工程指示 / 要求簡箋(E.I.)

工程指示編號：EI / 5213 / 22 修改版次： I
 工程編號 : J - 858 工程名稱 : 將軍澳日出康城 11
 工程項目 : 幕牆 防水片和基仔面防煙片 地盆用 (銘化)
 收件人 : 生統 發件人 : Helen Chak 日期 : 27/03/2023

Project Proposed Residential Development at TKOTL 70RP, Phase 11, Lohas Park, Tseung Kwan O, New Territories
Works Main Contract
Contract No. J3931
Ref. No. P19084NT/RFI/A/474 (Rev.2)
GECCL Ref. J3931/304/D09353
Date 31 Jan 2023
To / Attn RLP / Mr. Kenneth Wong / Mr. Florence Cheung
Subject Request for information of size for R.C curb at Tower 1 - 3 Flat AB

美特鋁質有限公司 MIDI Aluminium Fabricator Ltd.			工程號 J858 地盘 康城11期	類別 制圖 W. E. X	物料號 - 2022-08-11	圖號 FS-15-227
修改 - 日期 -	採用工廠 材料颜色 CHROMATE	地盤 ✓ 材料 1.5mm THK. 铝板	图纸名称 铝防水板加工图	復核 - 批准 -	數量 - 單件重量 - (KG)

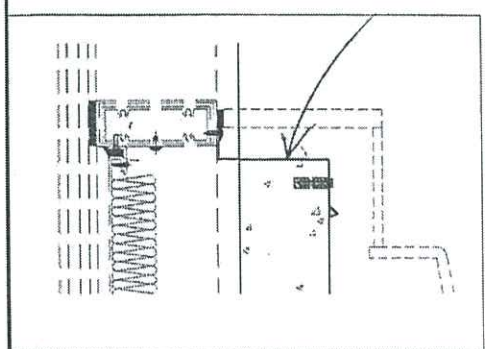
I 版: FS-15 加長, (因應則師 comment 浴室位置), 如已做或已出貨, 請重做。

取消
此部份

取消此

3D-VIEW

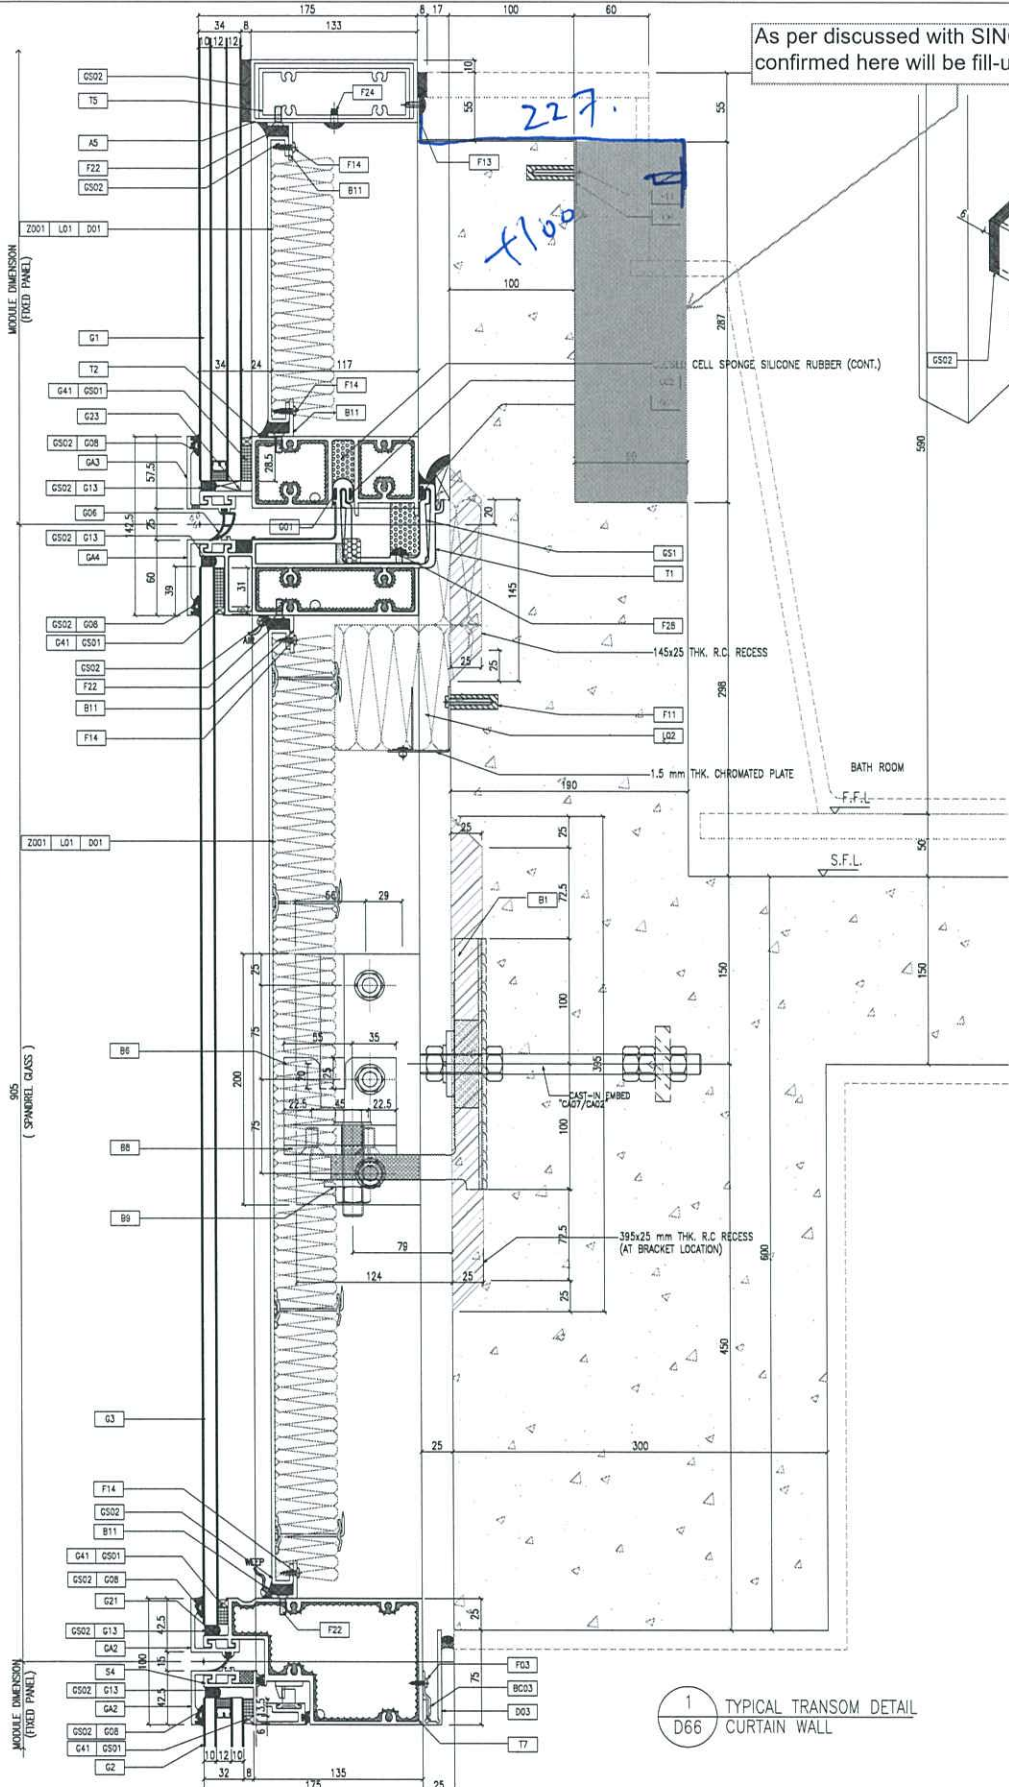
As per discussed with SINO & Moty, it is confirmed here will be fill-up the concrete.

Location Plan of Tower 3 Flat A-B

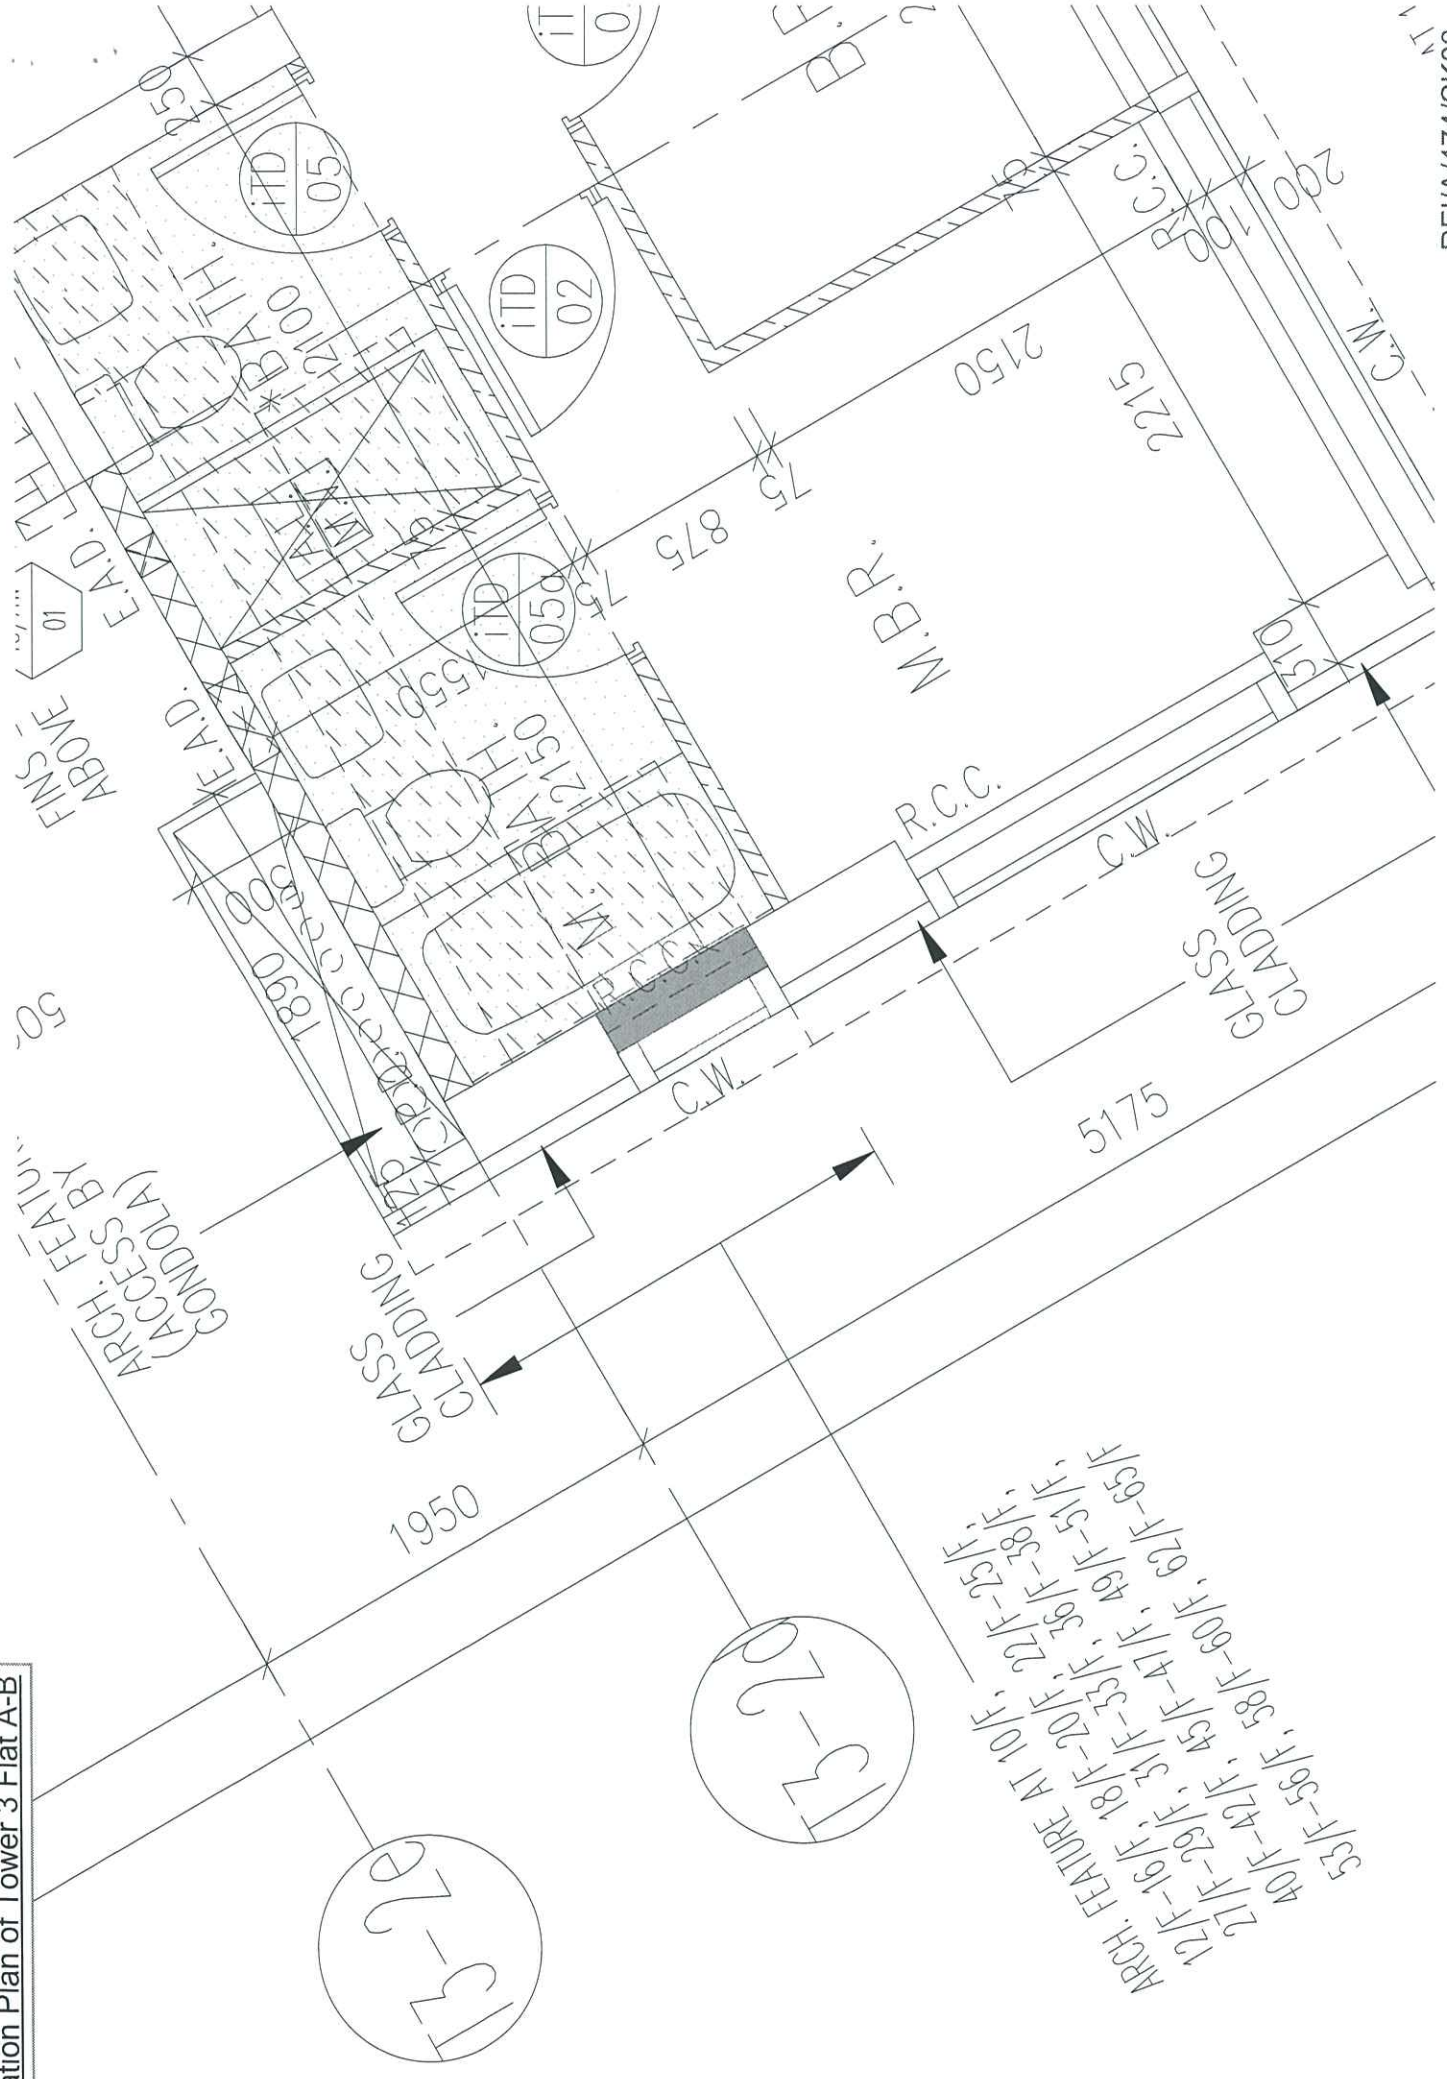
1. Confirmed that the R.C. curb will be revise the size and shape as per the attachment.

Response Please ensure proper waterproofing detail to be applied between the bathtub finish and RC curb. Please coordinate with Midi and interior sub-contractor for such detail.
